Water Right Conditions Tracking Slip

FILE # # G-17889

PUBLIC INTEREST REVIEW FOR GROUNDWATER APPLICATIONS

TO: Water Rights Section Date October 10, 2014
 FROM: Groundwater Section Phillip Marcy/Karl Wozniak
Reviewer's Name
 SUBJECT: Application G- 17889 Supersedes review of _____
Date of Review(s)

Water Levels in Nearby Basalt Wells

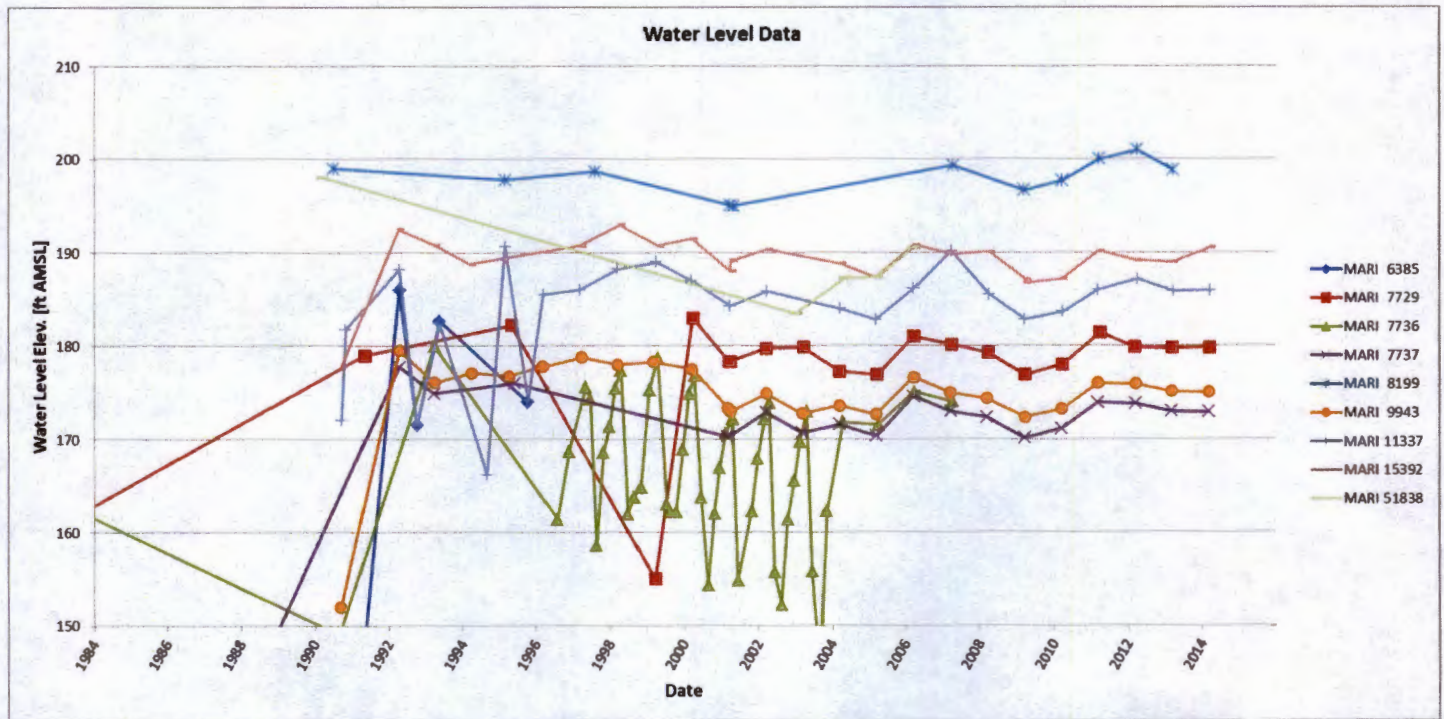
Water levels in nearby basalt irrigation wells to the north and west show stable water levels over the last twenty years. Limited data indicate that seasonal fluctuations are on the order of 10-20 feet. Many basalt irrigation rights have been issued in the area over the last 30 years but the extent to which all of these rights are exercised in any given year is unknown. However, stable water levels suggest some additional capacity for development. Well logs for nearby basalt irrigation wells show a median yield of about 450 gpm and a range from 60-800 gpm. This indicates that water is likely to be available in the amounts requested.
